Part No. 85-6230

# INSTALLATION INSTRUCTIONS

## RUN SOLENOID FOR GROUNDMASTER® 580-D

Figure 1

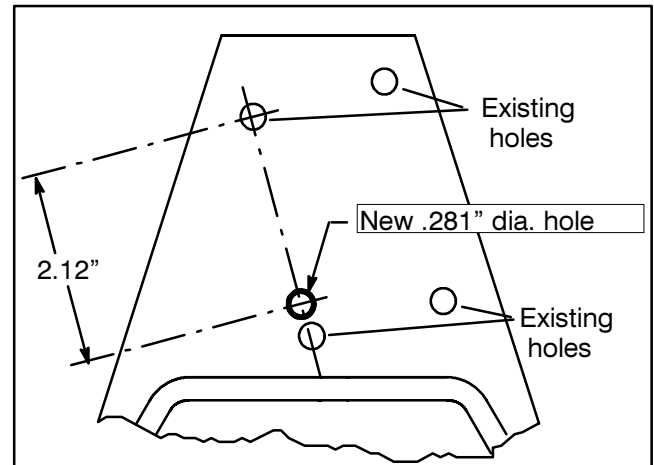
**Note:** This run solenoid has (2) mounting holes instead of (4) as in the old solenoid. The hole spacing for the new solenoid is different than any (2) current holes in the mounting bracket. Using dimensions shown in figure, locate and drill a new .281 dia. hole in mounting bracket.

Figure 1

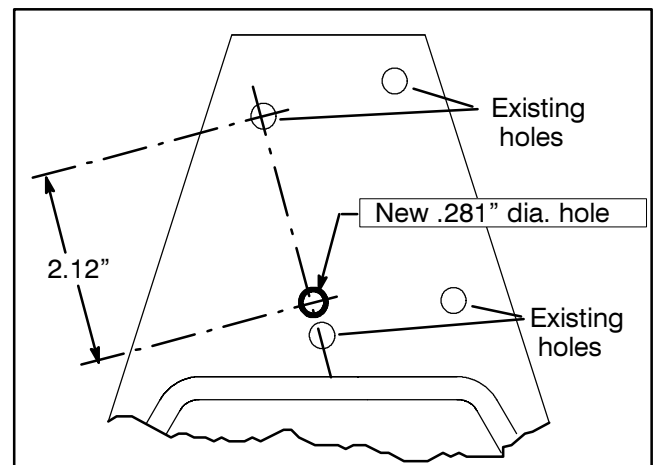
**Note:** This run solenoid has (2) mounting holes instead of (4) as in the old solenoid. The hole spacing for the new solenoid is different than any (2) current holes in the mounting bracket. Using dimensions shown in figure, locate and drill a new .281 dia. hole in mounting bracket.
